NUCLEAR REGULATORY COMMISSION

ADVISORY COMMITTEE ON REACTOR SAFEGUARDS

245TH MEETING

DATE: September 4, 1980 PAGES: 1 thru 308

FIGURE II 6-16 Reactor Protection System Reduced Fault Tree

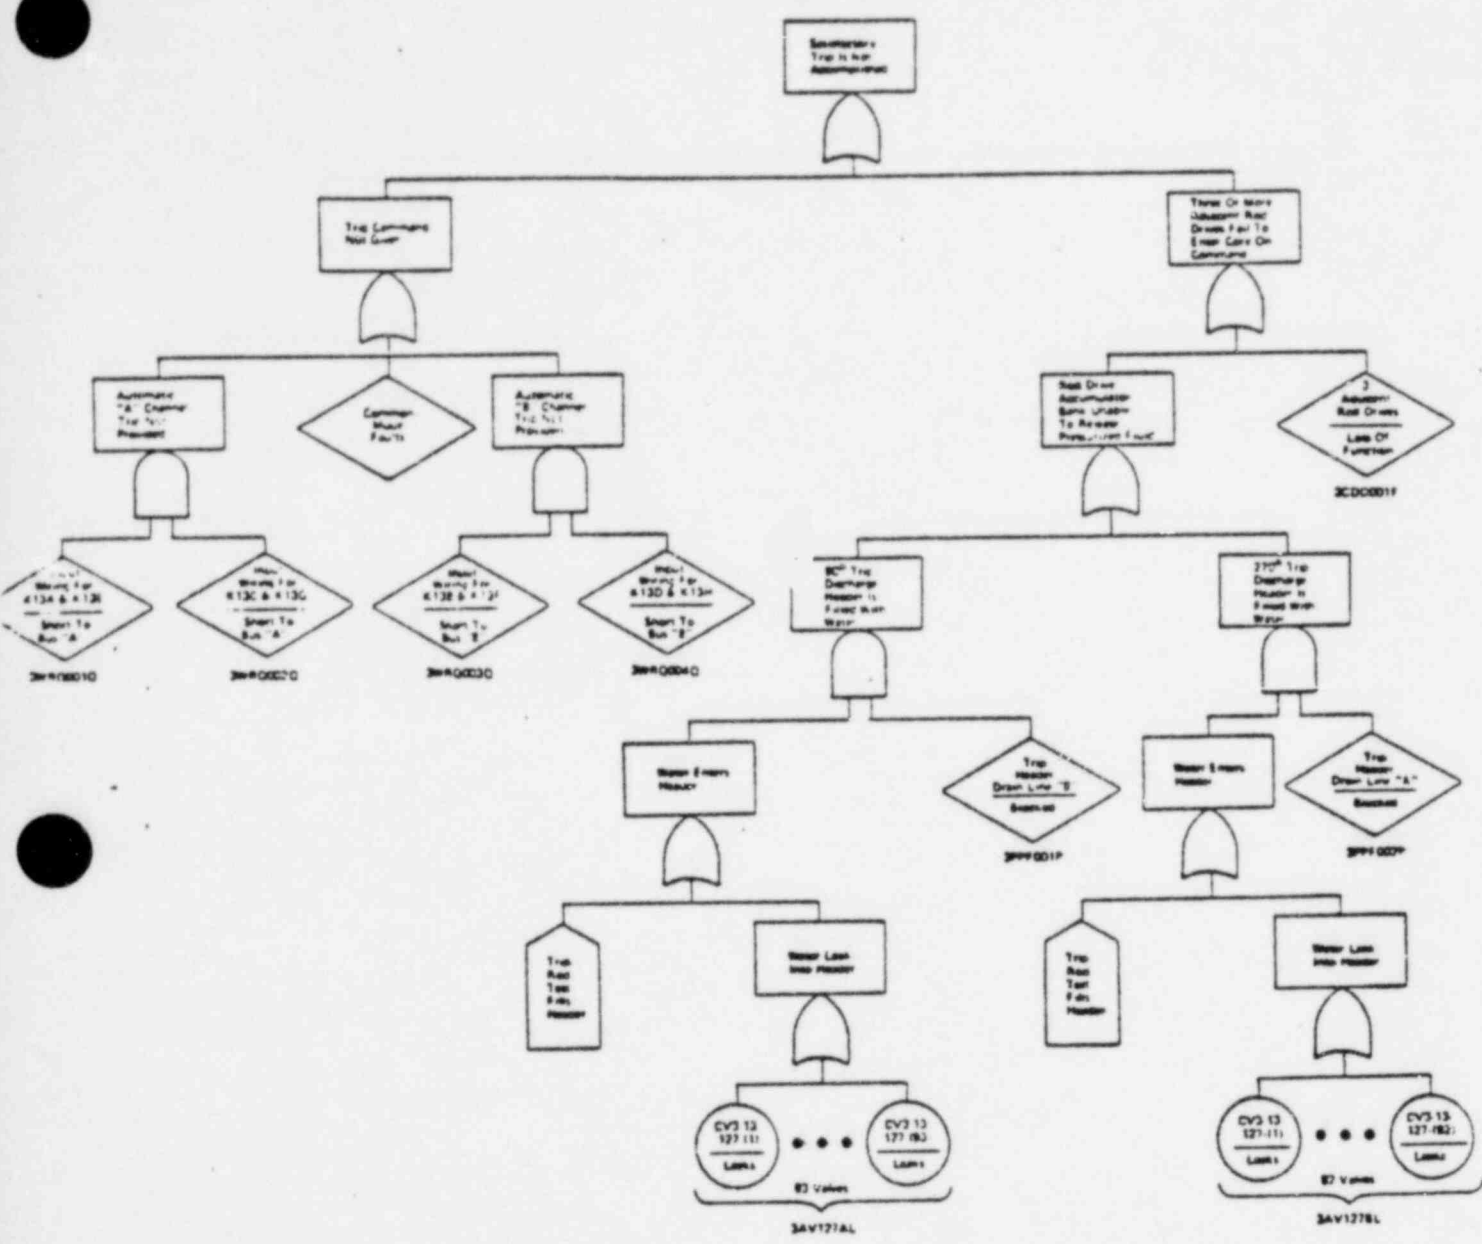
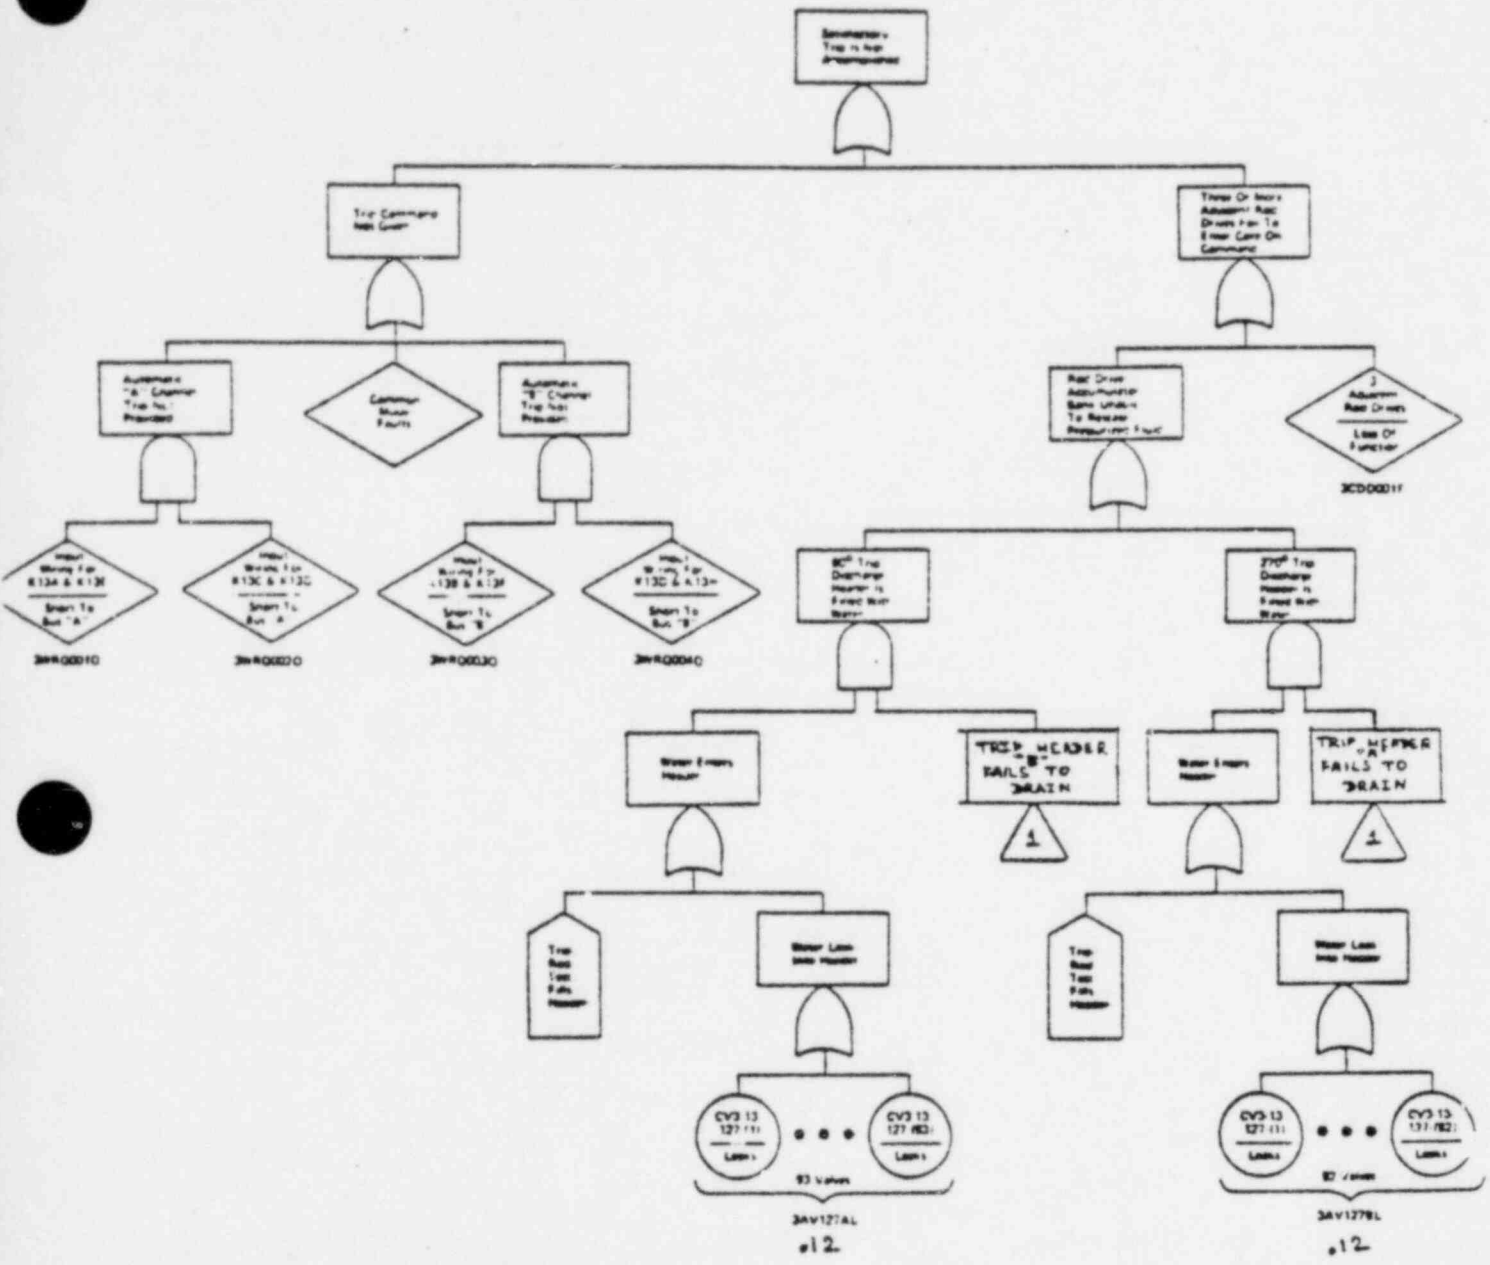
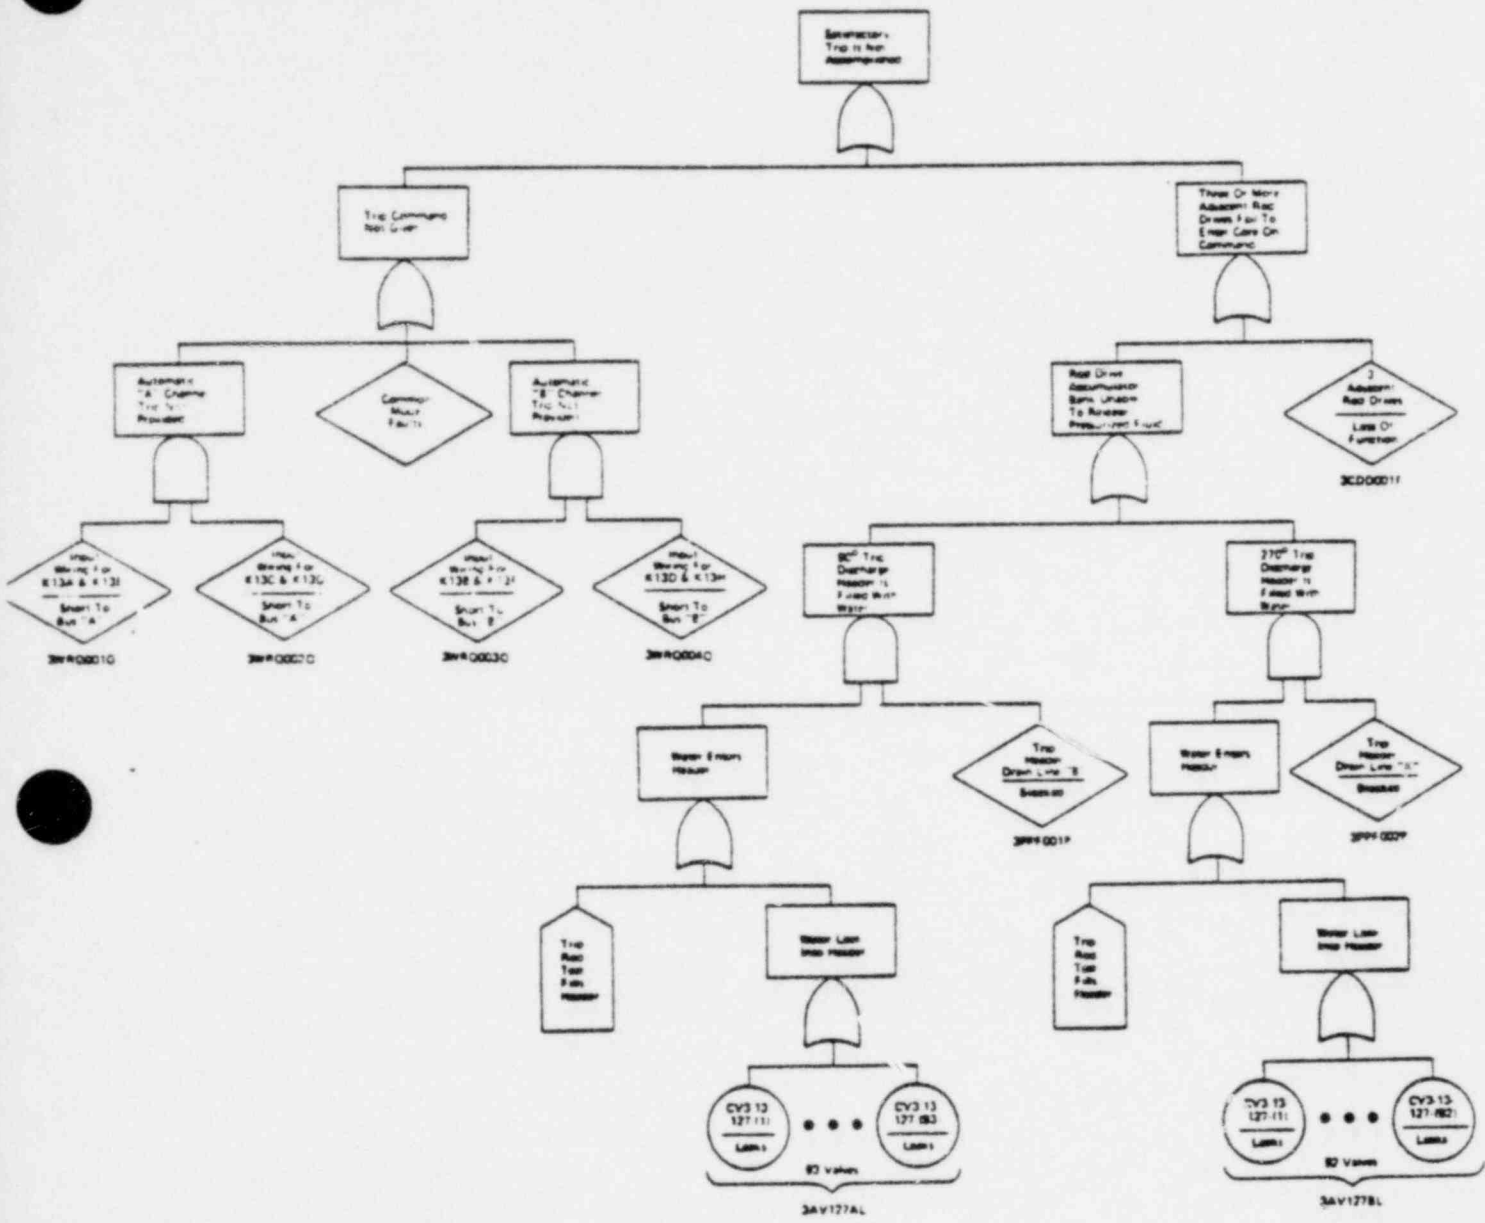
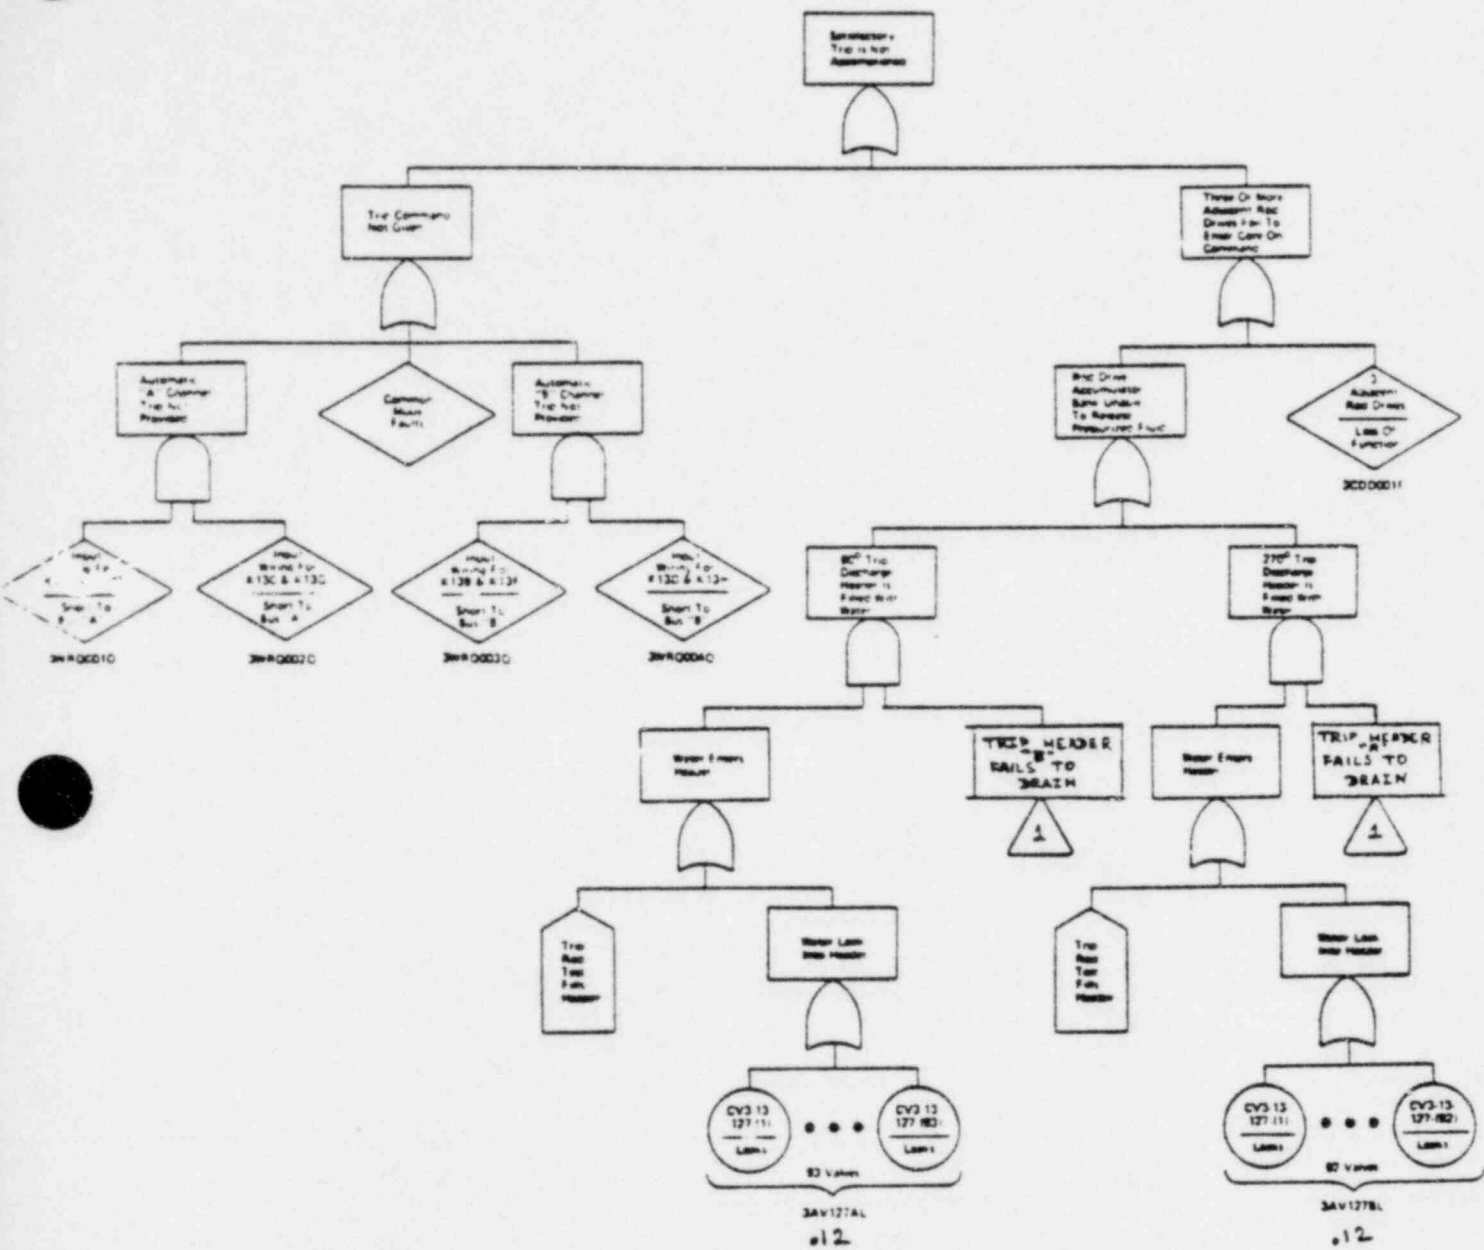
6 And as a result, some of the calculations done in
7 WASH-1400 are a little bit overly conservative that the
8 system will work. Now, what I have here is a fault tree for
9 the analysis done for a failure to complete a successful
10 scram for Peach Bottom. This is similar to the Browns Ferry
11 plant in that it has that two-inch drain line. At least now
12 it does. Soon it will be changed. But it still has the
13 two-inch drain line.

12 Now, what this would do for a plant like Browns
13 Ferry is simply slow the rate of drainage down. But it may
14 be significant enough to prevent the system from draining
15 properly, or your vent line itself is plugged. Again, you
16 have the original vent which was on the original WASH-1400
17 fault tree, which says, okay, the drain line is blocked.
